LARAMIE COUNTY CLERK BOARD OF COUNTY COMMISSIONERS AGENDA ITEM PROCESSING FORM

TITLE: Review and action of a Subdivision Permit and Plat for Benz Subdivision

First Filing, located in Tract 13 and a portion of Tract 14, The Prosser

Tracts, Laramie County, Wyoming.

Attachment 6: Land Analysis Map – Revised 12/02/2013

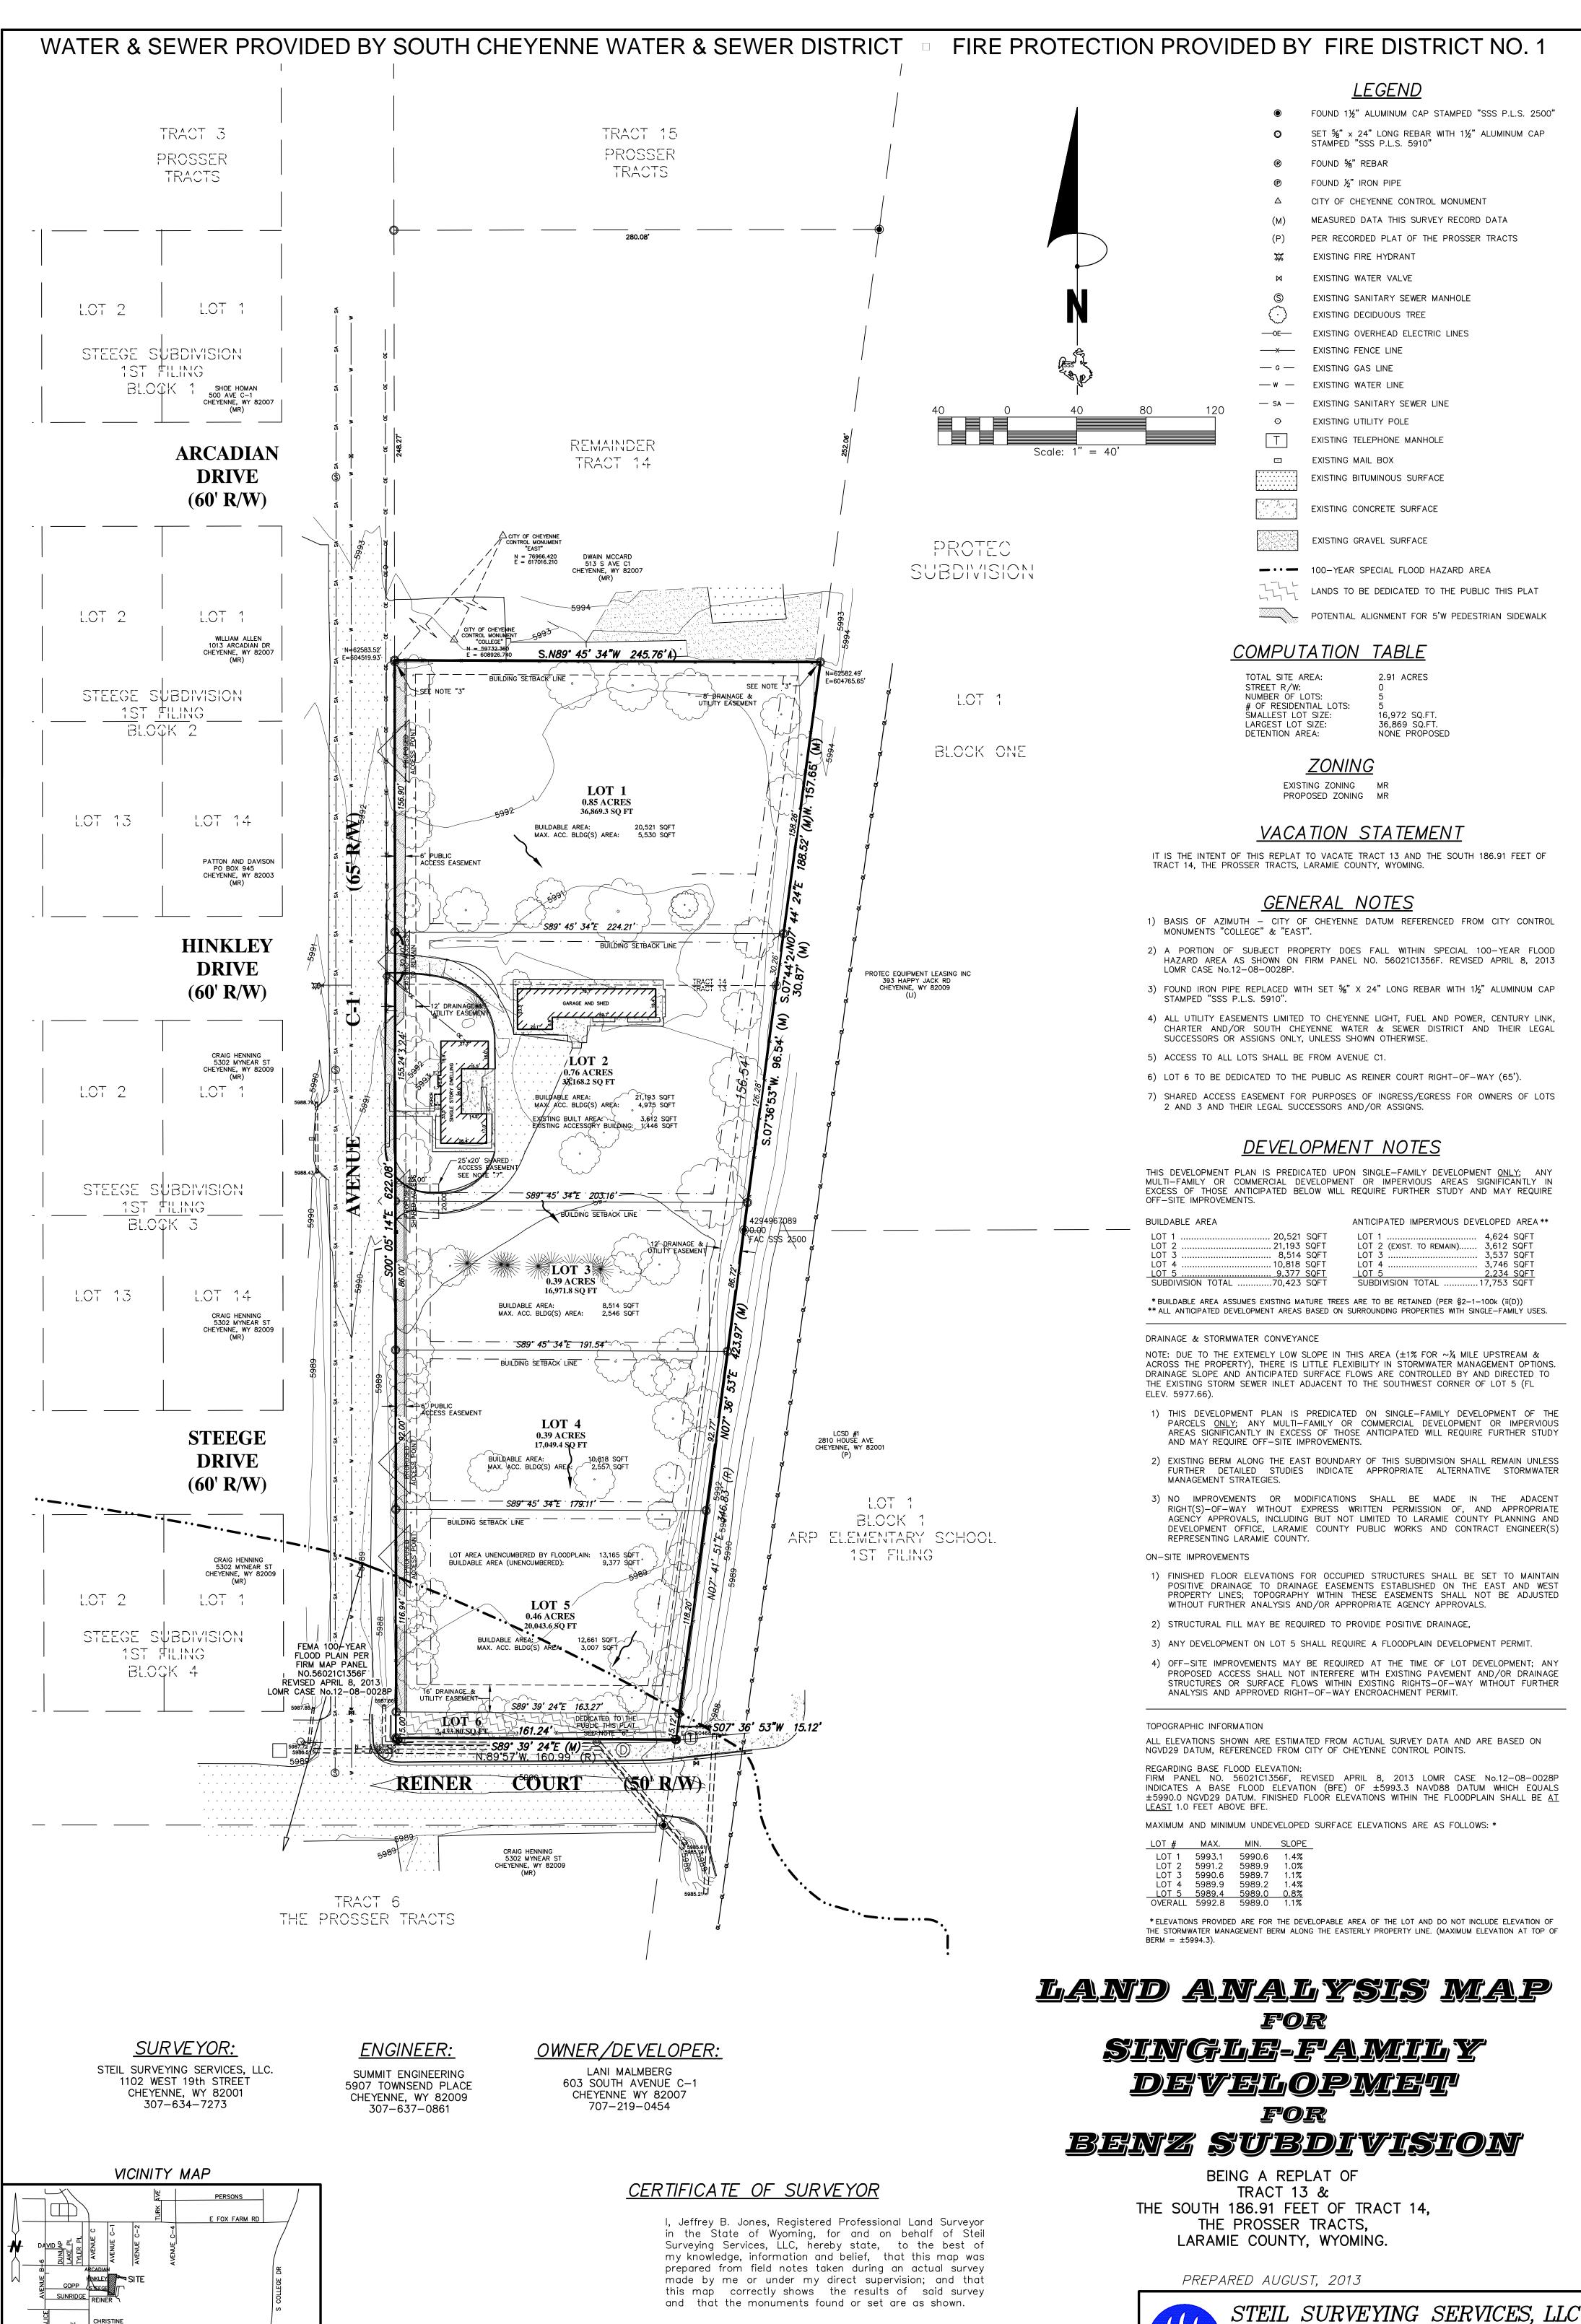
- 7. Looking at the Land Analysis Map, it would appear that there are numerous existing trees located within the drainage/utility easements along the lots. I assume the intent would be to preserve as many trees as possible and, if so, how will drainage ditches and utilities be installed? My concern would be that the trees/vegetation may prohibit the proper installation of drainage ditches to insure the drainage can easily move from one lot to the next and through each lot. As a result, I would recommend that

In lieu of a full Drainage Report, Applicant completed a Land Analysis Map (revised 12/02/13). The Land Analysis Map located existing structures and trees on the property, indicated the extent of the FEMA 100-year floodplain, and topographic features for drainage, addressing initial comments from the County Engineer, Public Works, and City of Cheyenne. This Analysis assumed single-family development; future multi-family or non-residential uses would require complete site plan review. Concerns with drainage focused on two issues: protecting future development from flood inundation, and protecting future development from overland drainage to the drain at Reiner Court and Avenue C-1. The Land Analysis map shows that Lot 5 has approximately 9,377 square feet of buildable area outside of the regulatory 1% floodplain; however, there is still substantial area within the 0.2% (500-year) floodplain (See FIRM Panel detail). A Grading, Erosion and Soil Control (GESC) will be required to confirm site work conforms to planned on-site drainage systems.

Attachment 7: Plat - Revised 12/02/2013

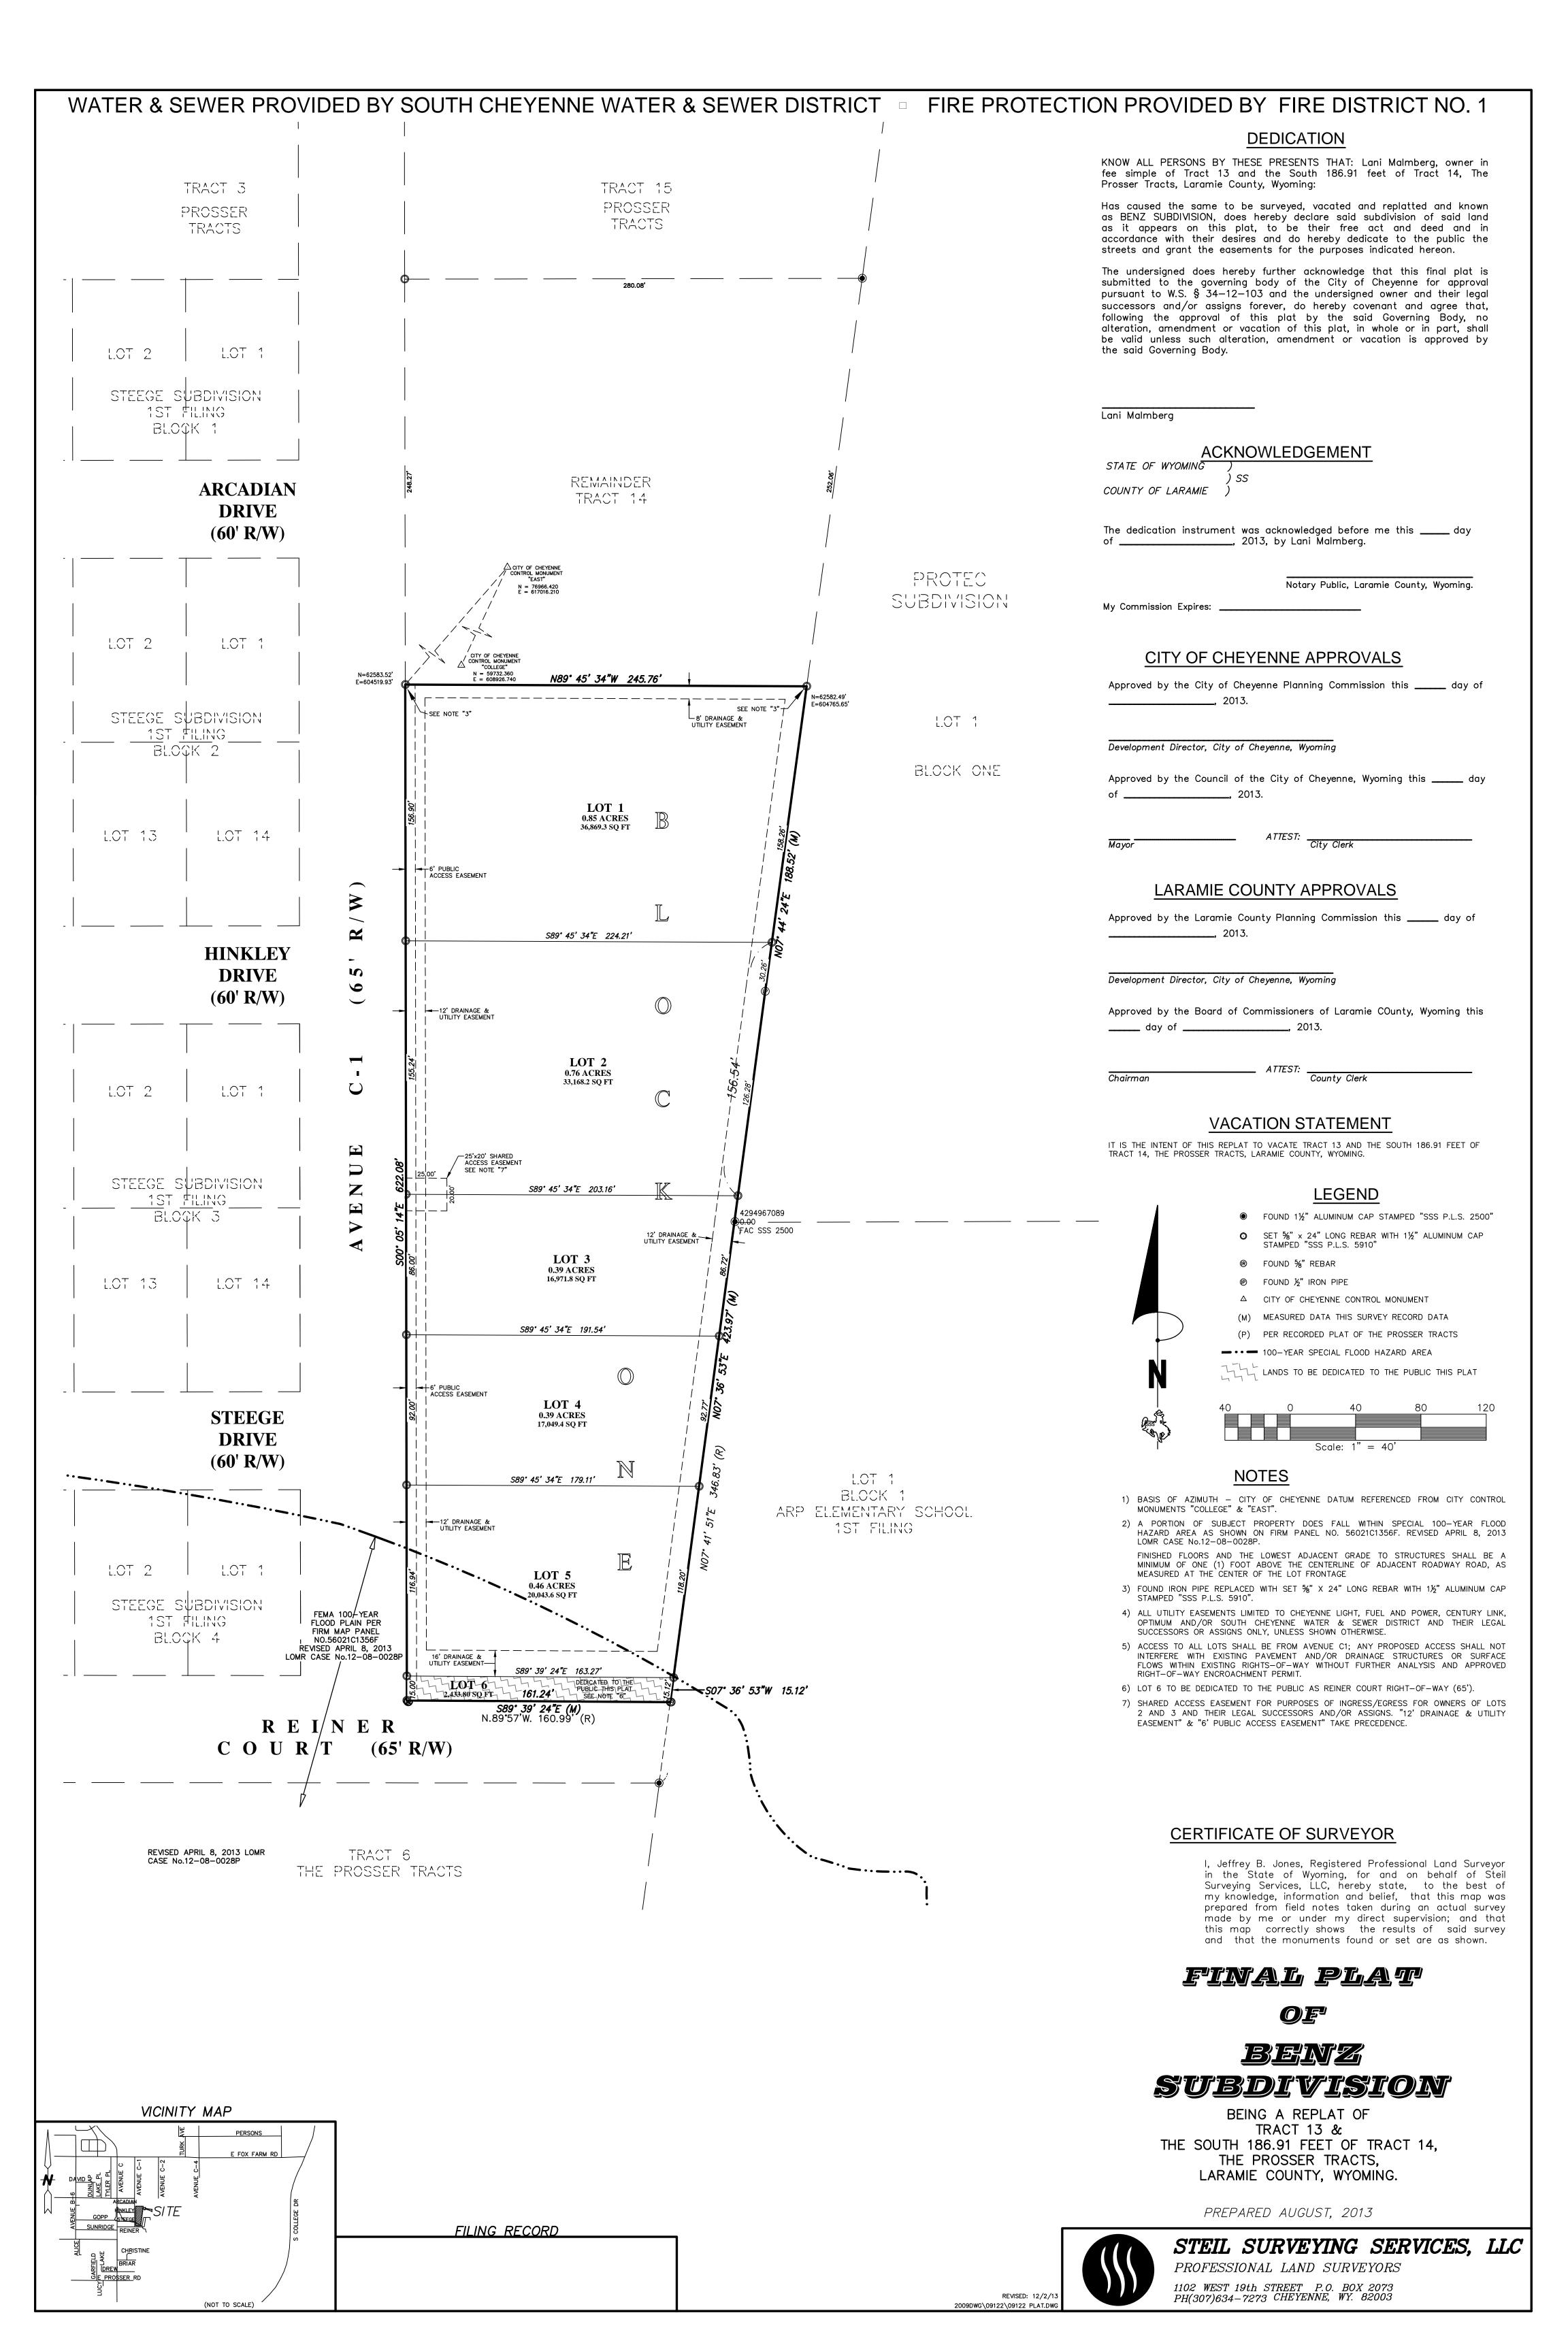
Utility Easement". Does Note 5 on the plat drawing preclude drainage from the easements? Does Note 5 need to be modified to ensure the easements can be used for drainage as well?

Benz Subdivision will create five (5) new lots ranging from 16,972 square feet to 36,870 square feet, and dedicate an additional 15' of public right-of way on Reiner Court. The dedication for Reiner Court is shown as "Lot 6" on the proposed plat. Staff recommends this be changed to a standard ROW dedication to avoid future confusion. The existing home and detached garage on Tract 13 were built in 1936. The property is adjacent to Avenue C-1 and Reiner Court, which are both paved, generally with a rural profile. There are existing single-family residences located north of the property, vacant residential lots to the west, a mobile home park to the south, Arp Elementary School to the southeast, and industrial development (including Niobrara Energy Park) to the east and northeast.

- **6.** "Lot 6" shown on the plat shall be re-labeled as Right of Way dedication instead of a subdivision lot, prior to recordation.
